04-10-2019 Town Council Meeting
Responses to Council Questions

ITEM #7: Consider an Application for Zoning Atlas Amendment - Independent Senior Housing, 2217 Homestead Road

ITEM #8: Consider an Application for Special Use Permit - Independent Senior Housing, 2217 Homestead Road

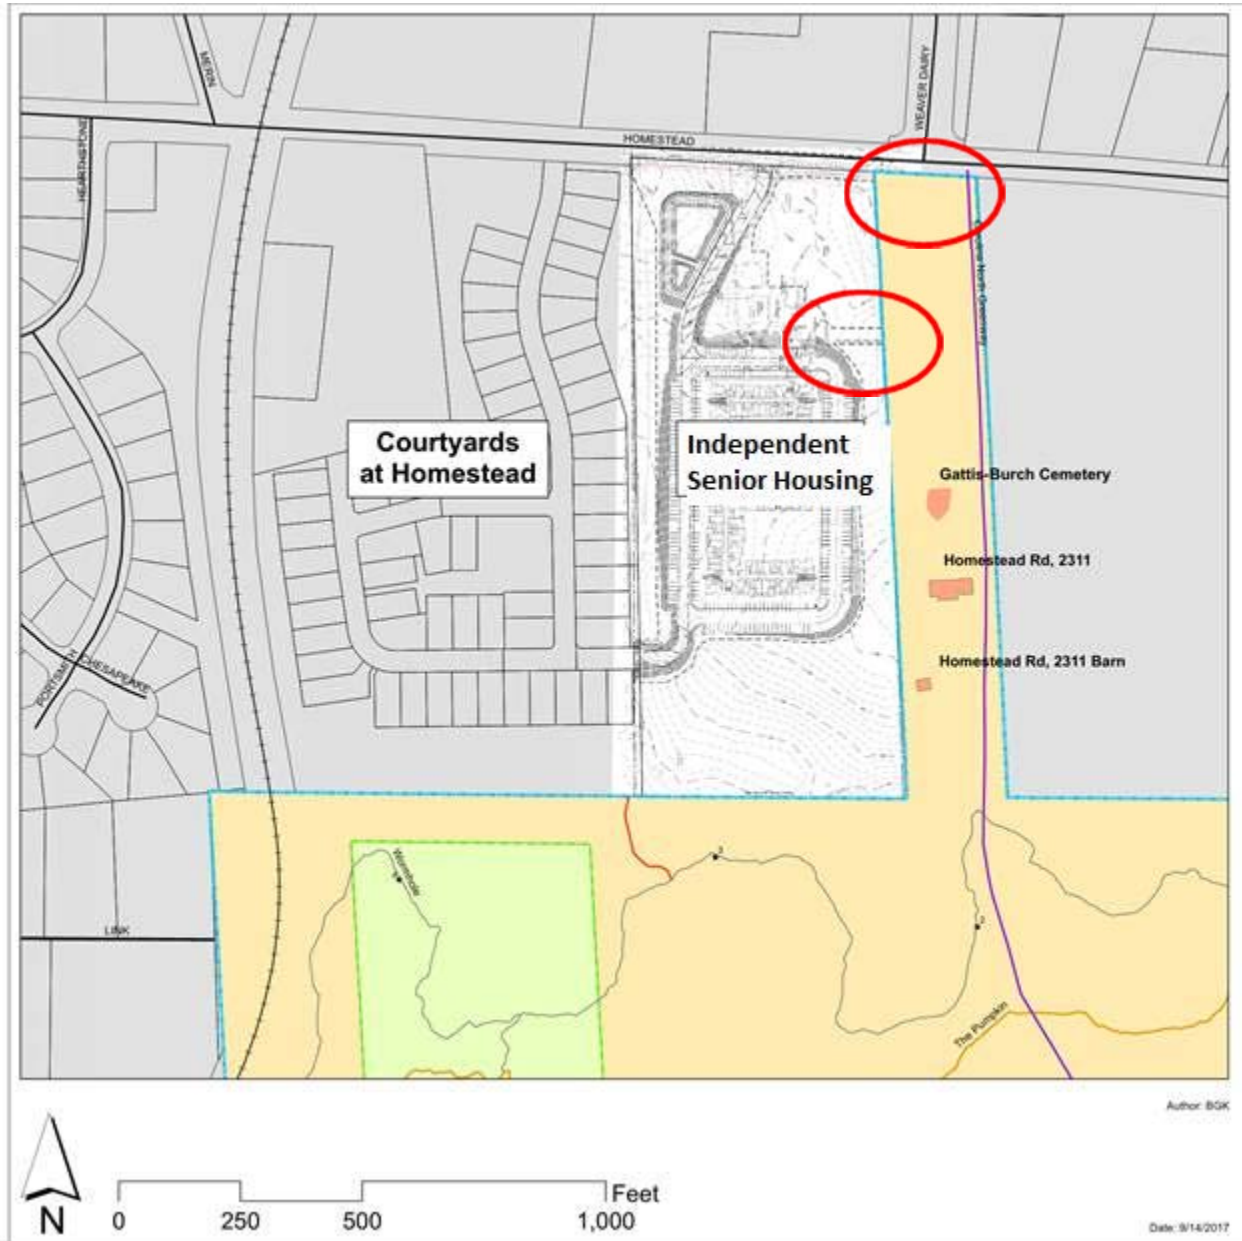
Council Question: Why is the applicant requesting a building height of 60 feet for a 4-story building? Architectural plans for other apartment buildings we have reviewed show a little over 10 feet per floor. Does the building height include mechanicals on the roof? How tall are the mechanicals above the roofline?

Staff Response: *The proposed zoning district height limitation is 60 feet and the submitted application indicates a maximum height of 60 feet. The proposal before Council is for a 4-story building. If mechanicals are located on the roof, they would be subject to the height limitation as well.*

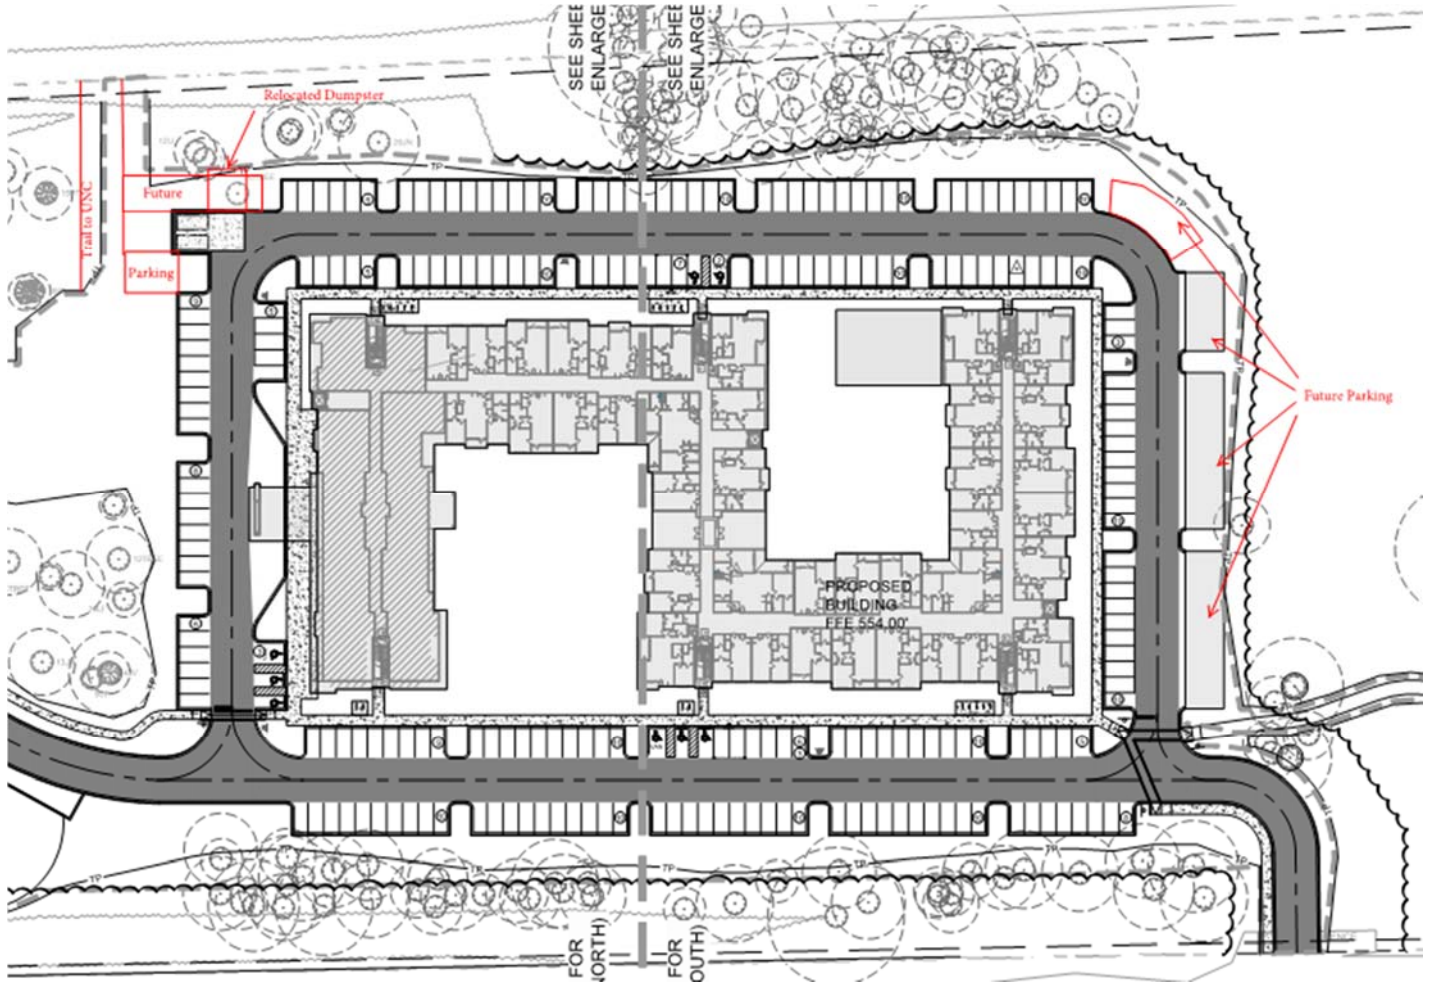
Council Question: What does the phasing plan for the proposed parking spaces look like?

Staff Response: The graphic below indicates the location of the phased parking areas.
